GEOTECHNICAL INVESTIGATION ORLEANS LEVEE DISTRICT PONTCHARTRAIN BEACH FLOODWALLS AND LEVEES NEW ORLEANS, LOUISIANA

ADDENDUM NO. 4
Pontchartrain Beach
Flood Protection Improvement Project
Phase II
Proposal No. 2040-0375
Lakefront Capital Improvement Program
The Board of Levee Commissioners
of the
Orleans Levee District
January 28, 1987

ADDENDUM NO. 1
Pontchartrain Beach
Flood Protection Improvement Project
Phase II
Proposal No. 2040-0375
Lakefront Capital Improvement Program
The Board of Levee Commissioners
of the
Orleans Levee District
January 22, 1987

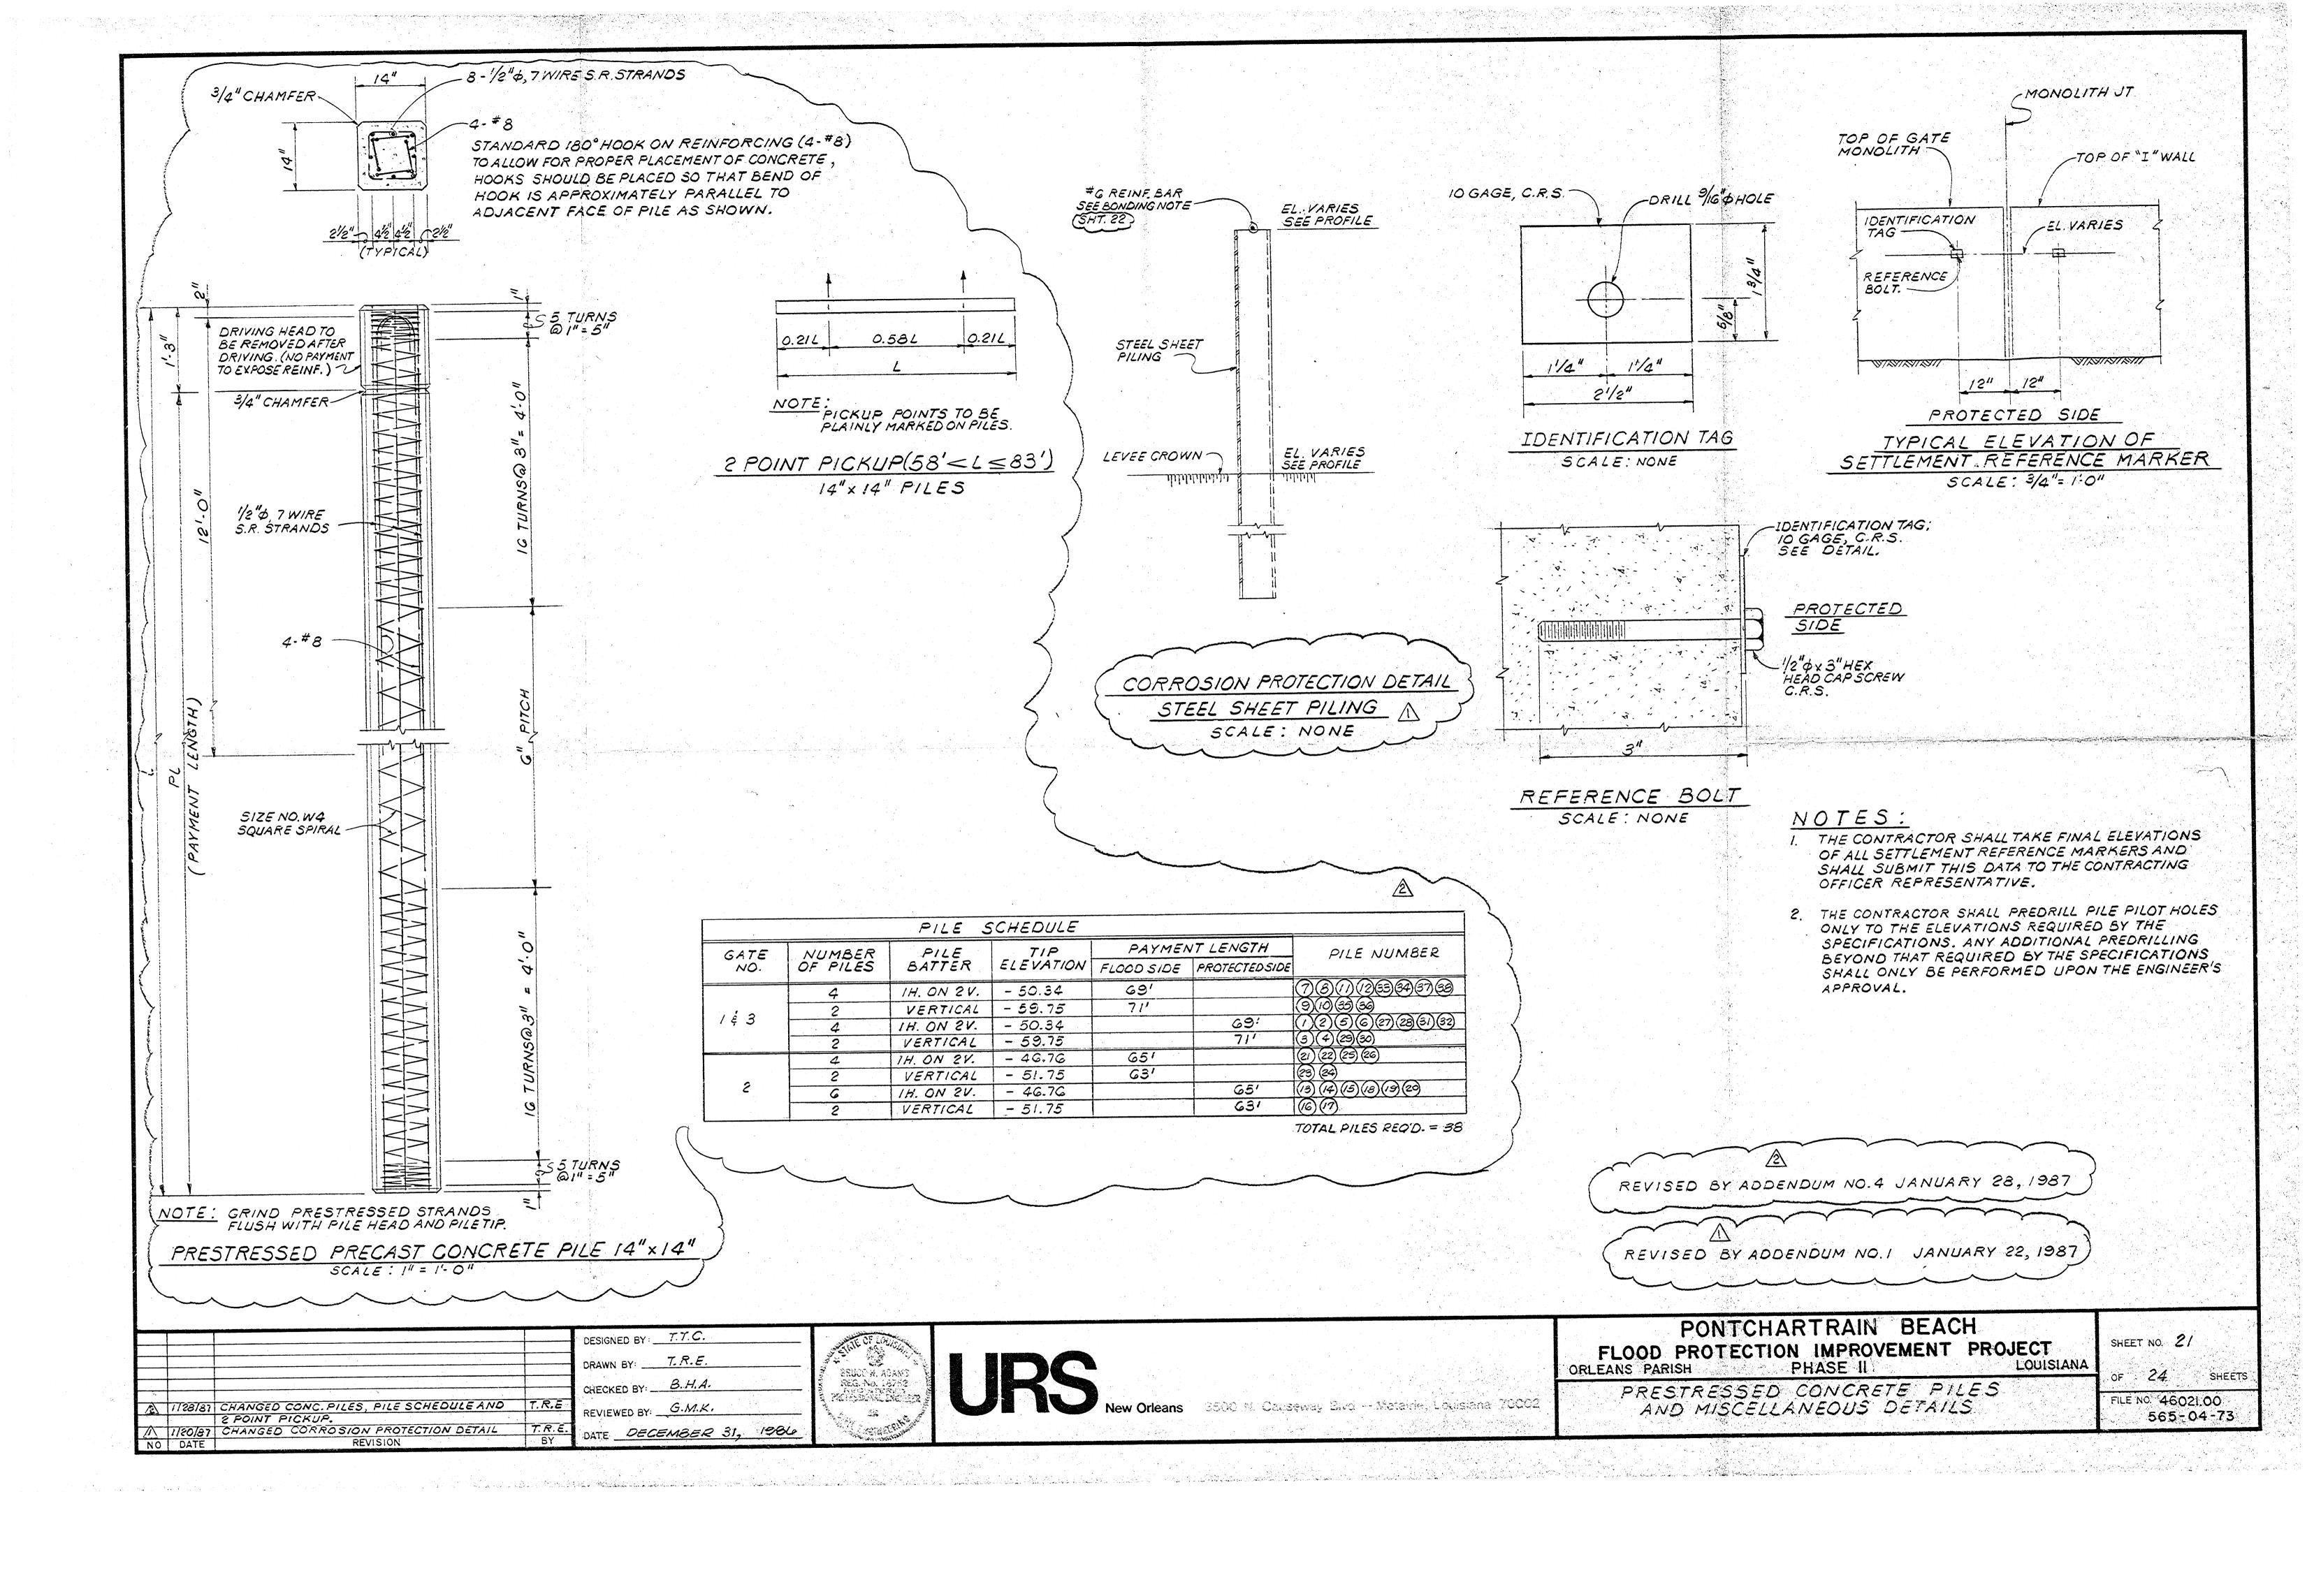
- Refer to Addendum No. 3 dated January 23, 1987 and Addendum No. 1 dated January 22, 1987. Disregard Item No. 2 of Addendum No. 3, and concerning Item No. 10 of Addendum No. 1, replace Sheet 21 Revised by Addendum No. 1 January 22, 1987, with the enclosed Sheet 21 Revised by Addendum No. 4 January 28, 1987 and Revised by Addendum No. 1 January 22, 1987.
- A. Refer to Addendum No. 3 dated January 23, 1987. Disregard Item Nos. 4 and 5 of Addendum No. 3 as well as page E-4 of the <u>Bid</u> <u>Schedule</u> as revised by Addendum No. 3.
 - B. Refer to Section 5, <u>Prestressed Concrete Piles</u>, Part 5-4, <u>Measurement and Payment</u> (page 5-7) of the Specifications. In part 5-4.B (page 5-8), <u>Basis of Payment</u>, after:

- 3. Refer to the project drawings. Change any references therein regarding the Prestressed Precast Concrete Piles or Piling from 12" square or 12" x 12" to 14" square or 14" x 14".
- 4. Refer to Section 5, <u>Prestressed Concrete Piles</u>, of the Specifications.
 - A. In the first sentence of paragraph 5.2.A.l (page 5-2), change "... 12-inch by 12-inch.", to "... 14-inch x 14-inch."
 - B. Change the third sentence of paragraph 5.2.B.7.a (page 5-4), to read, "The piling may be removed from the casting bed to nearby storage anytime after transfer of stress provided the maximum length does not exceed 83 feet for 2-point pickup or 58 feet for 1-point pickup."
 - C. In paragraph 5-4.B.l (page 5-7), change the reference '..."Piling, Concrete, Precast, Prestressed, 12-inch,"...', to '..."Piling, Concrete, Precast, Prestressed, 14-inch," for either Vertical Piling or Batter Piling,...'

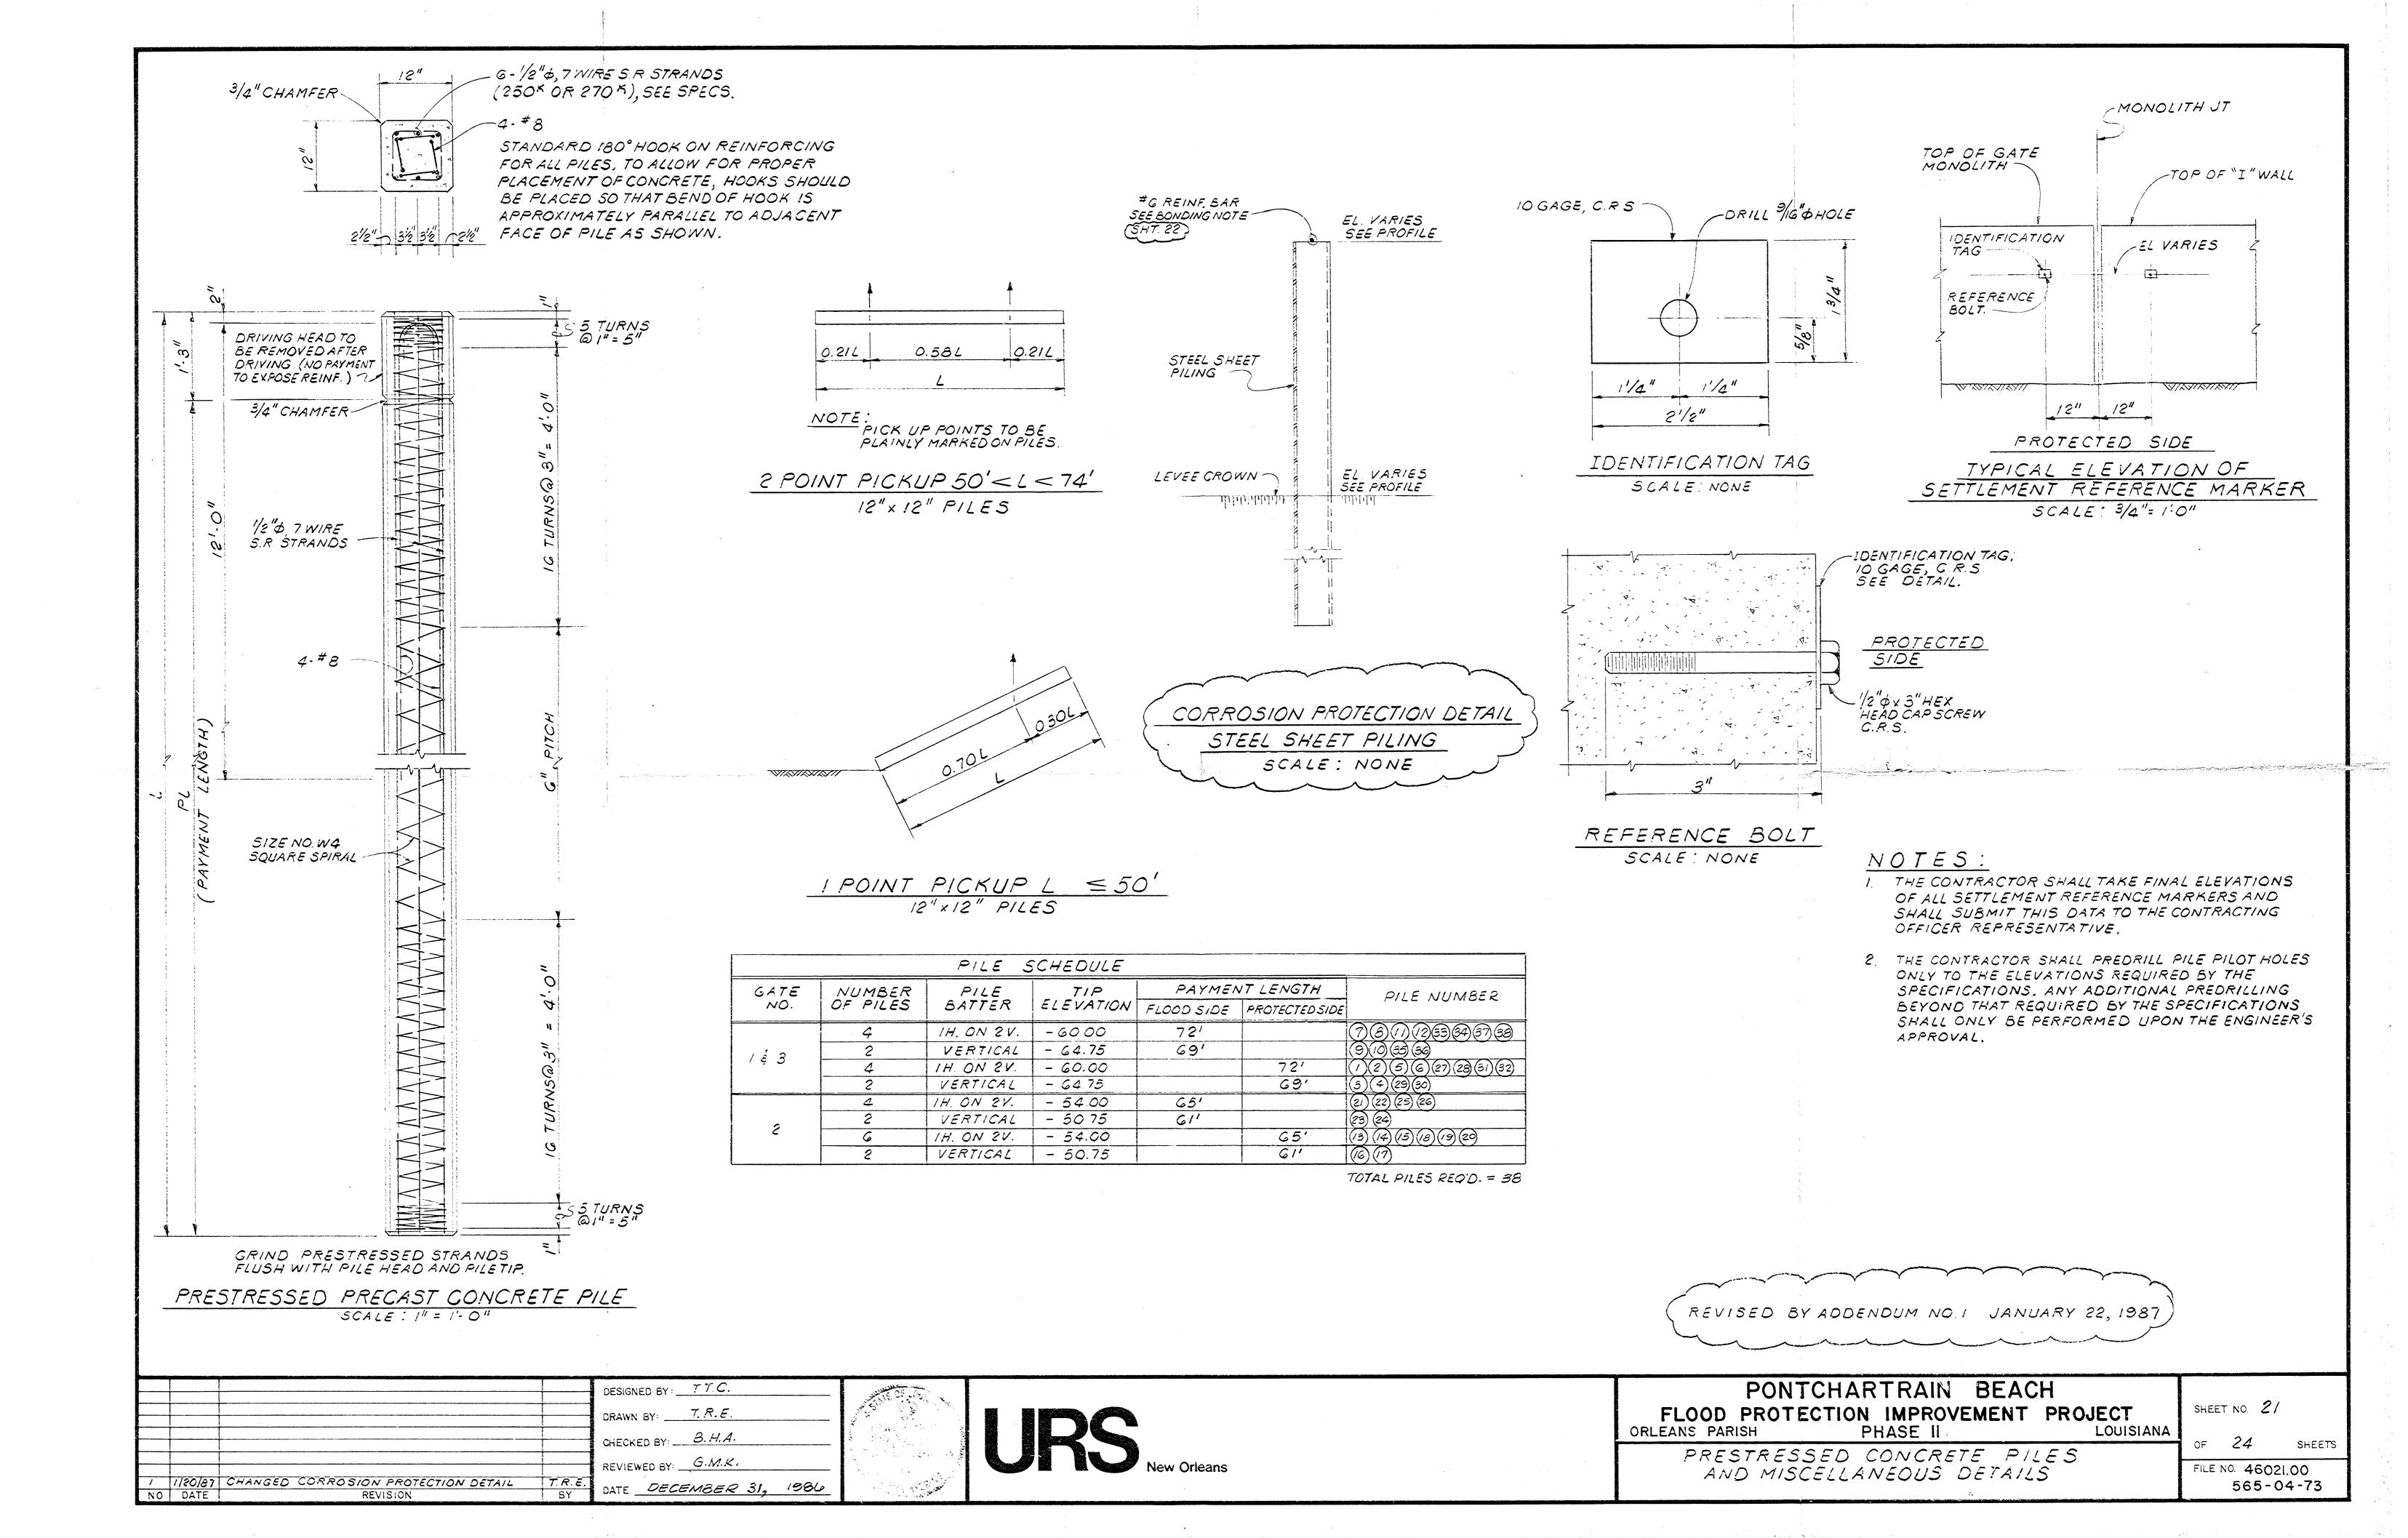
- 10. Replace sheet 21 of the project drawings with the enclosed sheet 21 as revised by this Addendum No. 1.
- 11. Refer to Item B-4.03 <u>Interpretations</u> (page D-2) of the Instructions to Bidders of the specifications. In the last sentence therein, change the last sentence to read as follows: "Questions received less than seven (7) calendar days (including weekends and holidays) to the time for opening Bids will not be answered".
